## Access Compliance Report Public Rights-of-Way (Curb Ramps)

Intersection ID: 19459 Main Street: ECHODALE\_DR Cross Street: NATIONS\_FORD\_RD Location: NW

ADA ID: B0E27B423BBA Ramp Type: PerpDiag Initial Pass/Fail: Fail Overall Compliance: No Severity Score: 21.25

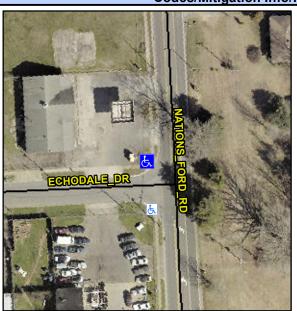
Remove & Replace Curb Ramp With Two New Directional Ramps or Equivalent.

Not Found, R304.5.1, R304.2.2

Field Measurements/Component Compliance					
Compliance Description		Data	Comp	oliance Description	Data
N/A	Ramp Length (in)	46.0	No	Ramp Slope (%)	11.4
No	Ramp Width (in)	44.0	Yes	Ramp XSlope (%)	0.7
N/A	Flare Type LT	N/A	N/A	Flare Type RT	N/A
N/A	Flare Slope LT (%)	N/A	N/A	Flare Slope RT (%)	N/A
N/A	Flare Traversable LT?	N/A	N/A	Flare Traversable RT?	N/A
N/A	Landing Length (in)	N/A	N/A	DWS Provided?	N/A
N/A	Landing Width (in)	N/A	N/A	DWS Contrast?	N/A
N/A	Landing Slope (%)	N/A	N/A	DWS Length (in)	N/A
N/A	Landing X Slope (%)	N/A	N/A	DWS Full Width?	N/A
N/A	Landing Curb? (Y/N)	N/A	N/A	DWS Offset (in)	N/A
N/A	Shared Landing?	N/A			
N/A	Gutter Ponding?	N/A	N/A	Gutter Slope (%)	N/A
N/A	Gutter Lip Ht (in)	N/A	N/A	Gutter X Slope (%)	N/A
N/A	Painted X Walk1?	No	N/A	Painted X Walk2?	No
	X Walk 1 Direction	To S		X Walk 2 Direction	To E
N/A	X Walk 1 Width (in)	N/A	N/A	X Walk 2 Width (in)	N/A
	X Walk 1 Slope (%)	0.0		X Walk 2 Slope (%)	2.1
